**Report by the Mining & Petroleum Gateway Panel  
to accompany a Conditional Gateway Certificate  
for the Caroona Coal Project**

**July 7th 2014**

The Mining & Petroleum Gateway Panel (the Gateway Panel) has determined an Application for a Gateway Certificate by Coal Mines Australia Pty Ltd (the Applicant) for its proposed Caroona Coal Project in the New England Northwest region of New South Wales. The Gateway Panel finds that the Application does not meet all of the Relevant Criteria and consequently issues the Applicant with a Conditional Gateway Certificate. This report provides both the opinions and the reasoning of the Panel.

Figure 6. Individual soil pit numbers and location relative to landscape slope categories (MSM, 2014a)

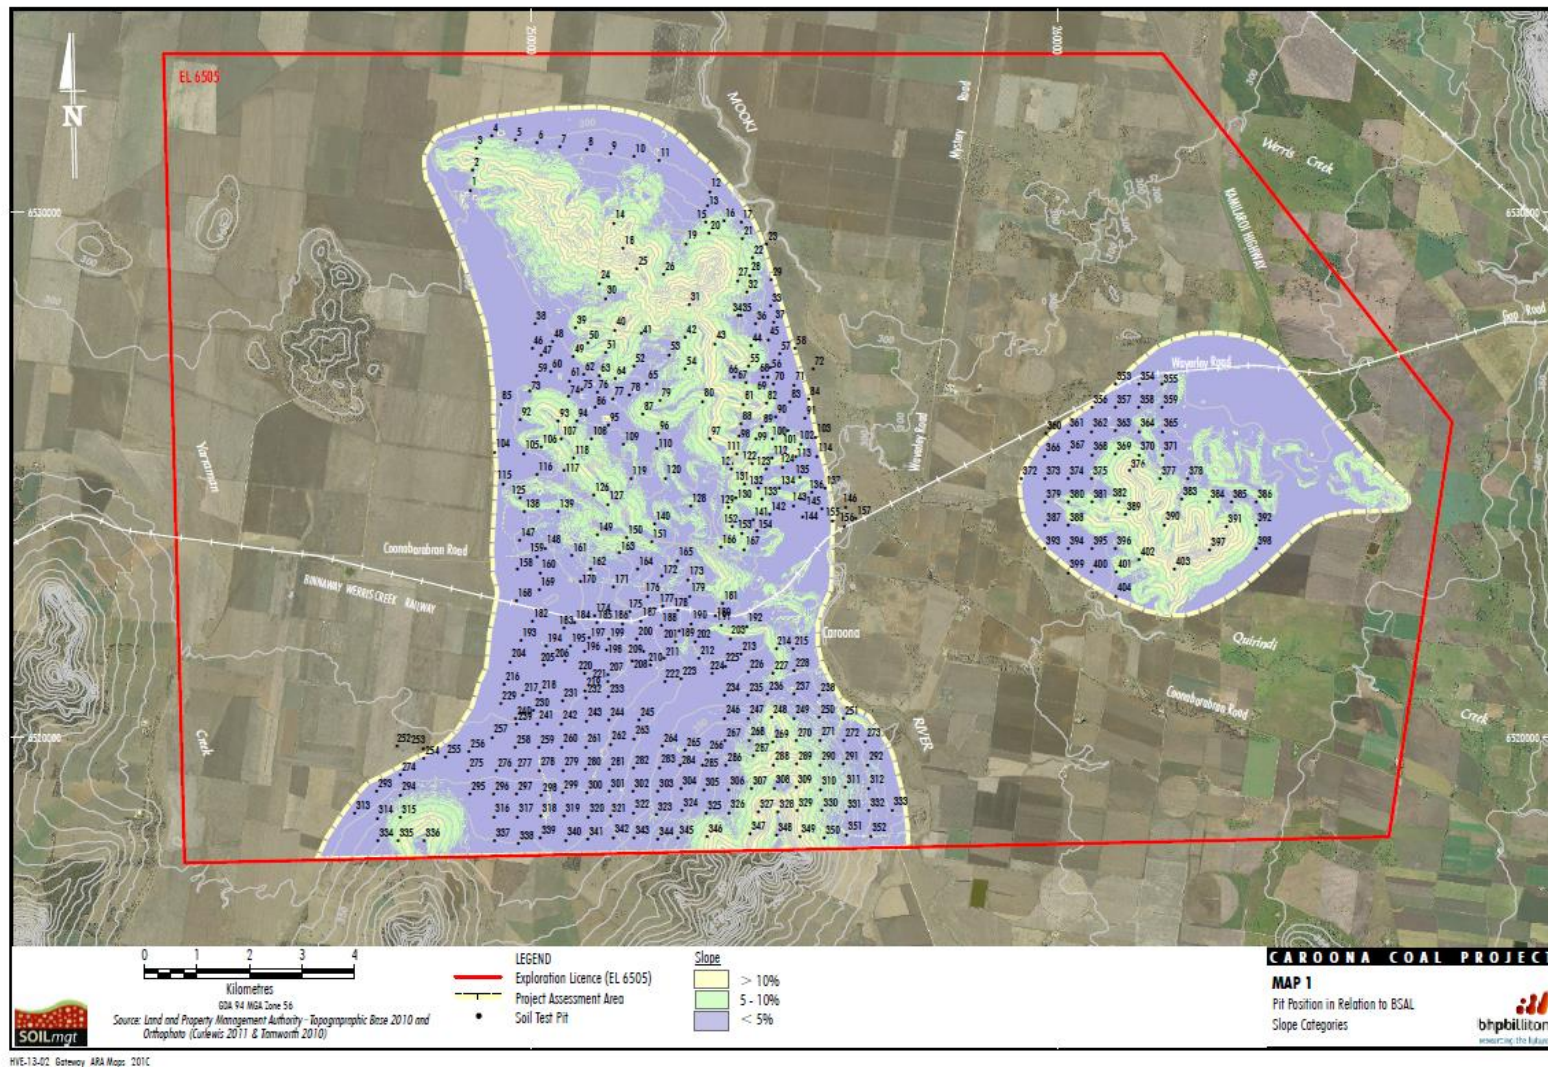
The Gateway Panel notes that pit sites 21, 26, 31, 43 and 32 in the north east of the Doona Ridge section of the PAA are identified as individual BSAL locations. These points appear to bound an area that, while it includes landscape with slope >10%, also appears to include more than 20ha of landscape with <10% slope (Figure 6). Given there are no sample sites within the bounded area and that the sampling density around these locations, particularly along the north west and south east boundaries of the area is often greater than the '1 sample per 16 ha', the Gateway Panel believes that there is potential for verified BSAL (<20ha) in the area. Sampling at an increased spatial density is therefore warranted in this area.

The Gateway Panel suggests that this process alone is insufficient for fulfilling the drainage verification process. Firstly, the use of mottling as the dominant indicator of 'waterlogging depth' is contentious as 'mottling does not necessarily imply that oxidising and reducing conditions are currently occurring in the soil in most years' (Isbell 2002). Second, the NCST (2009) include the possibility that 'some horizons may be mottled' in the 'imperfectly drained' soil classification, which meets BSAL verification criteria. Third, the Gateway Panel notes that a depth criterion for mottling or waterlogging has not been established in the published verification protocol (OEH & OASFS, 2013), therefore setting the 0-750mm limit (equal to the criteria for depth to physical or chemical barrier) is subjective. Setting a critical depth equal to the depth criteria for soil pH and salinity (0 – 600mm) could be considered more appropriate. There are 41 sites in the PAA where mottling/waterlogging is identified in a soil layer that begins at 600mm depth and is also the only criterion preventing the site from being identified as BSAL. A number of these sites are adjacent to the area bounded by

identified BSAL soil in the north east of Doona Ridge discussed above or may elsewhere form contiguous areas of BSAL >20ha. The Gateway Panel recommends the BSAL classification at these 41 sites be reassessed. Ideally, as stated in OEH & OASFS (2013), saturated hydraulic conductivity should be measured to determine internal drainage rates.

**Figure A1. The surface geology, topographic contours of the project area and surrounding regions (HydroSimulations 2014). Included in the above map is a major geological fault along the northeast margin of the Nicholas Ridge.**

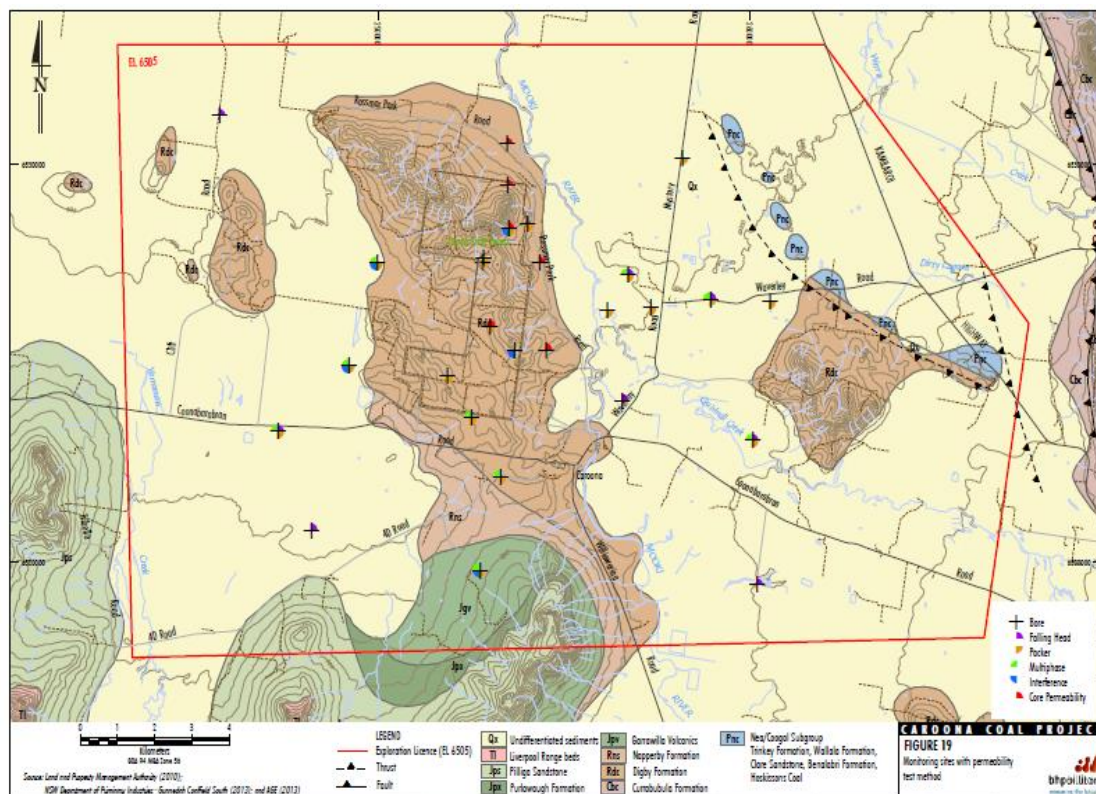
Such data would improve the level of detail over that present in the application and would have avoided the following notable omission. The surface geology data provided by one section of the applicant (HydroSimulations, 2014: reproduced here as Figure A1) shows a major fault and consequent subsidence of the major target coal-bearing sequence along the northeast part of Nicholas Ridge.

The subsidence study (MSEC 2014a-e) omits this fault, or any similar relevant subsurface data acquired by the applicant, from this and other relevant cross-sections (Figure A2). The fault on the geological surface map (Figure A1) overlies at least the first two long wall panels of the cross section but is not evident in the applicant's subsidence cross section (Figure A3) which shows subsidence across these and other panels. The Gateway Panel notes that the stratigraphic sequence overlying the coal to be mined and each of the units will have a different response to strain, stress and fracturing induced by mine excavation.

The Gateway Panel considers that the applicant has sufficient information to assess the likely response of the sequence to the mining process – this would result in some greater degree of complexity in the pattern of surficial subsidence-related features than the applicant has outlined. The pattern of subsidence and cracking on the land surface would impact upon soil drainage and ponding of surface water. Ponding of surface water may result in the development of additional near surface salt build-up in the soil profile - as was noted in the soil survey sampling undertaken for BSAL identification.
